RE: Marsh Landing Generating Station
Application for Certification 08-AFC-03

Responses to Data Request Set 3b: (#99-101)

Application for Certification (08-AFC-03) for MARSH LANDING GENERATING STATION Contra Costa County, California

Marsh Landing Generating Station
 Mirant Marsh Landing, LLC Contra Costa County, California
REVISED FIGURE 63-1b

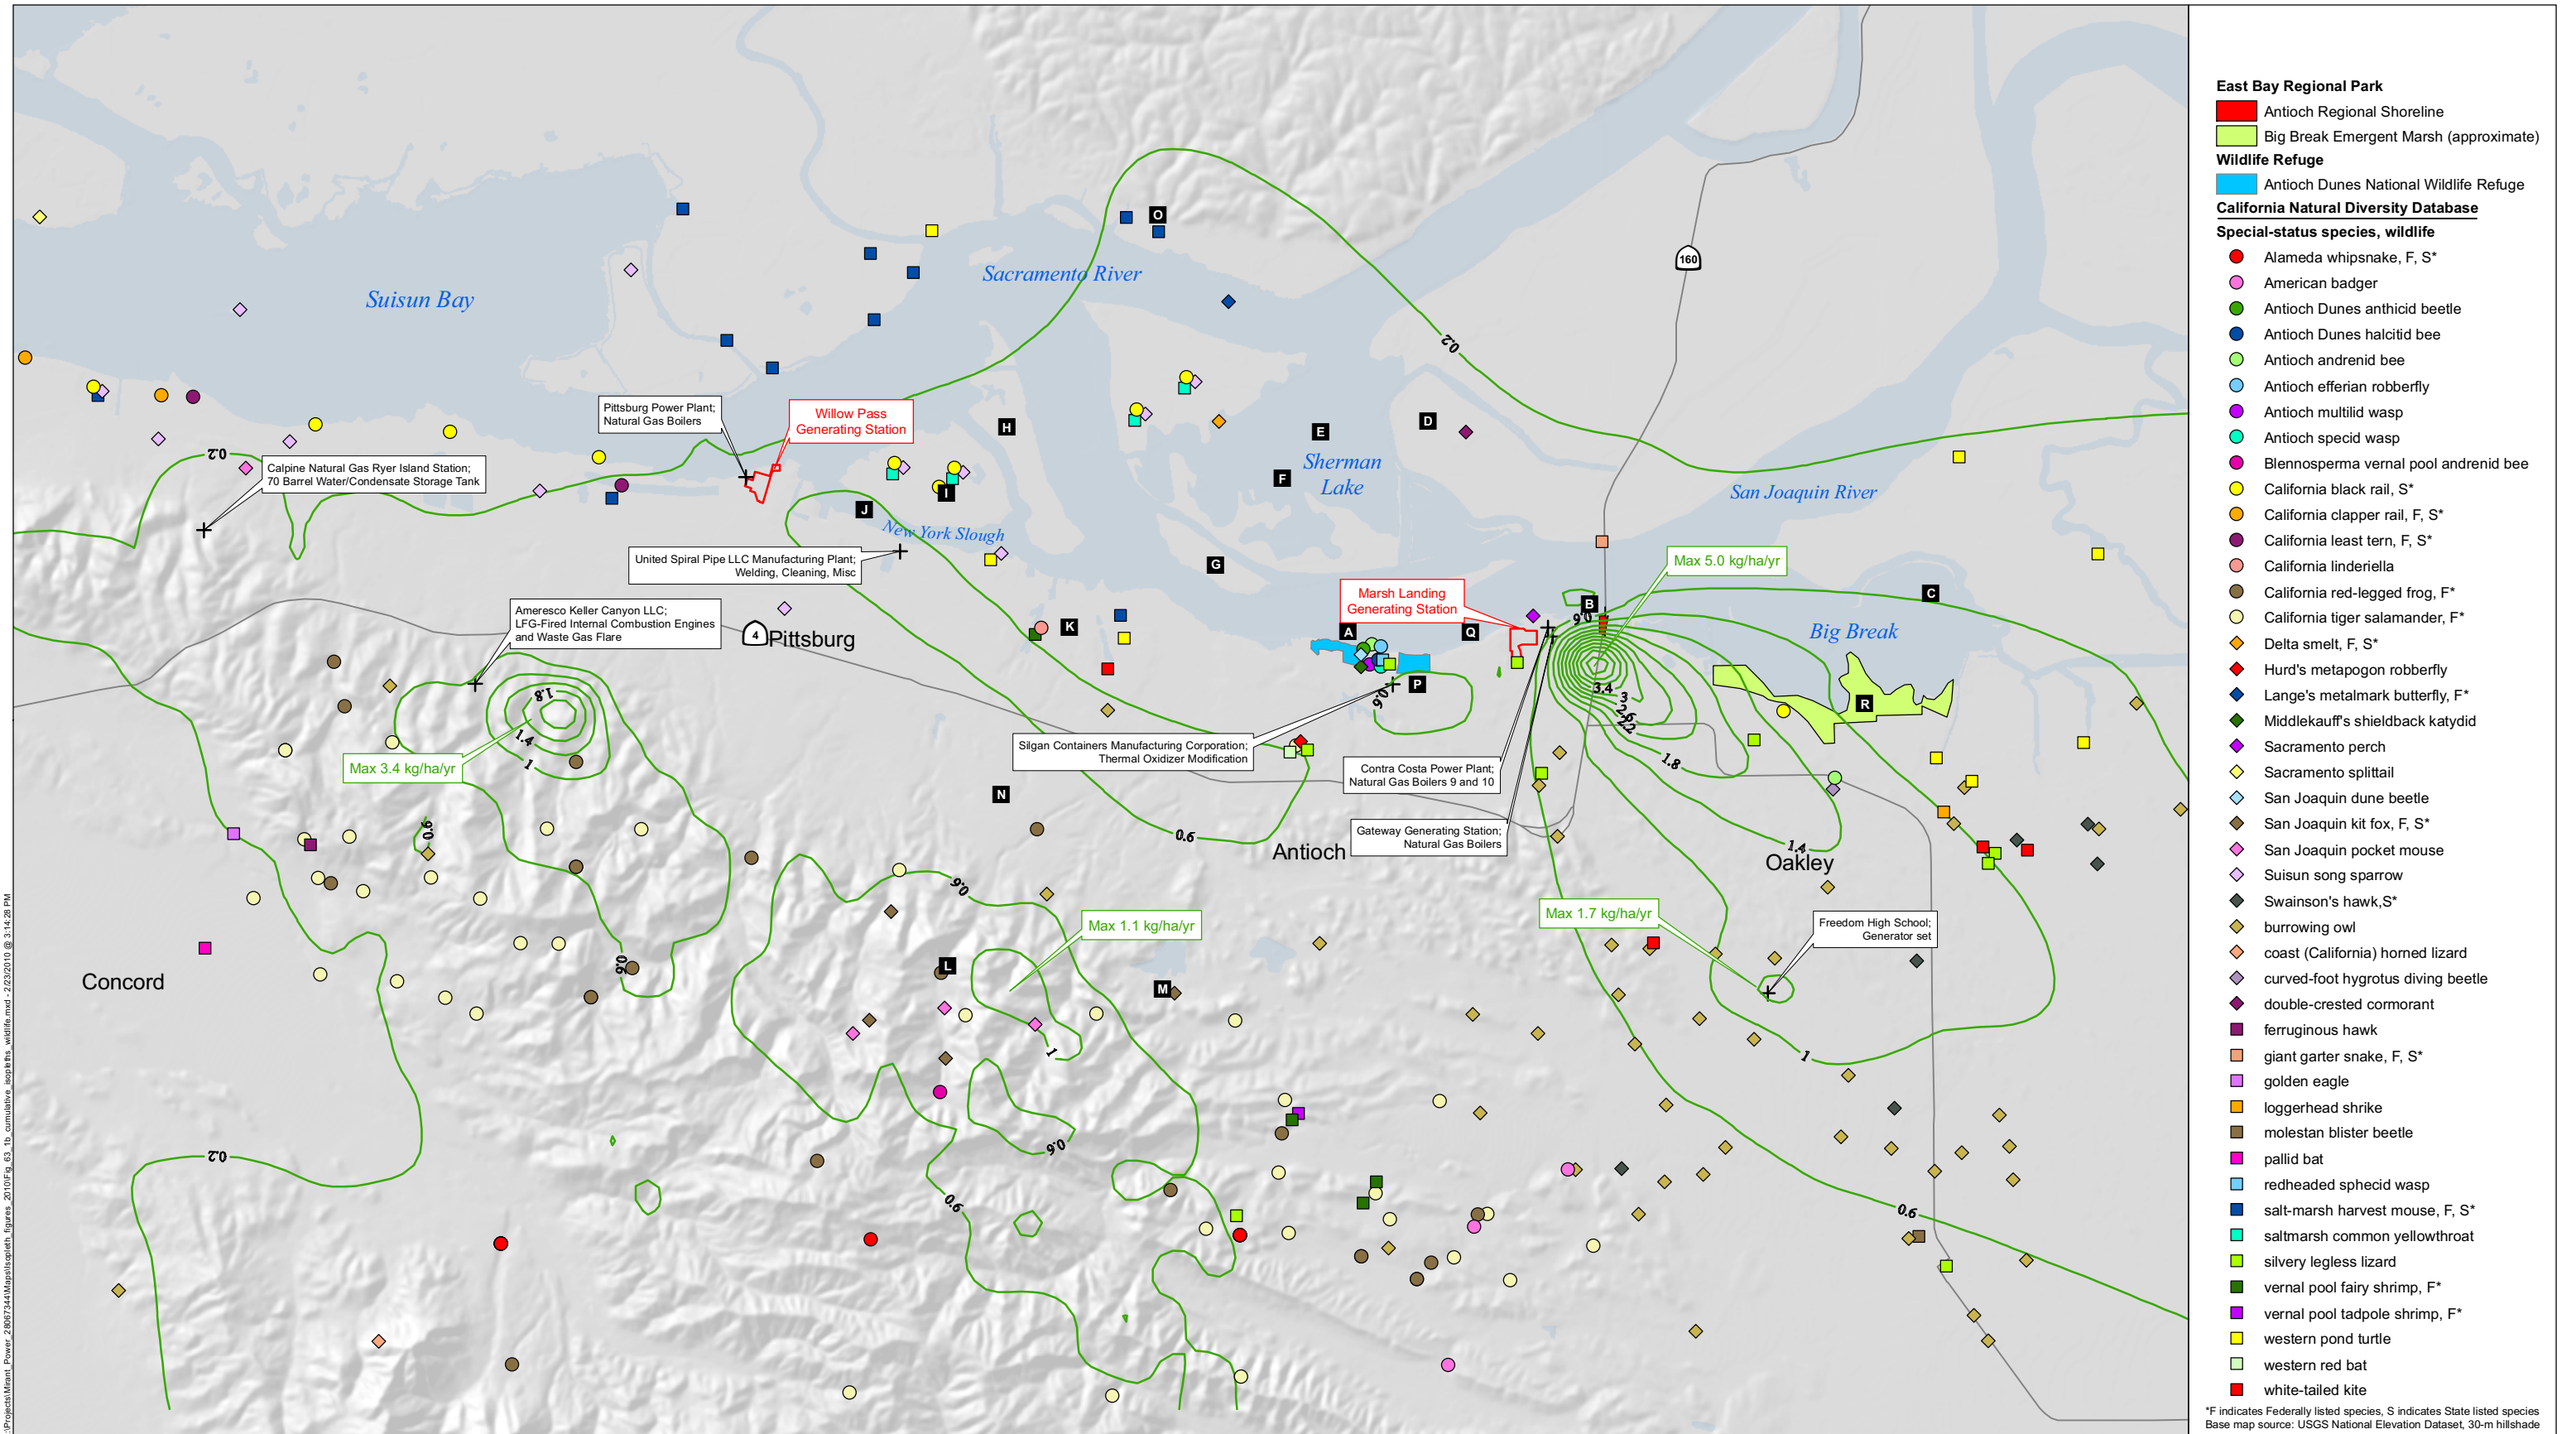
101 *Please update the cumulative impact analysis (Tables 9-1 and 9-2) in Responses to Data Request Set #1 – data request #9 – with nitrogen deposition values in kg/ha/yr. Provide an isopleth graphic over USGS 7.5-minute maps (or equally detailed map) of the direct nitrogen deposition values in the cumulative analysis.*

Revised Figures 63-1a and 63-1b provide the isopleths for nitrogen deposition rates in kg/ha/yr due to all cumulative sources listed in Revised Table 63-1. Revised Figure 63-1a shows the federal and state listed special-status vegetation species. Revised Figure 63-1b shows the federal and state listed special-status wildlife species.

As seen in Revised Figures 63-1a and 63-1b, the maximum cumulative nitrogen deposition value occurs approximately 0.5 mile southeast of the MLGS facility. The maximum nitrogen deposition rate for all cumulative sources is estimated to be 5.0 kg/ha/yr (without background) in this area. This area would exceed the benchmark of 5 kg/ha/yr with background, but it is not considered sensitive to nitrogen deposition because sands or serpentine soils are not known to be present. Almost all of the highest nitrogen deposition rates in this area are caused by nitrous oxide and NH₃ emissions from the Gateway Generating Station.
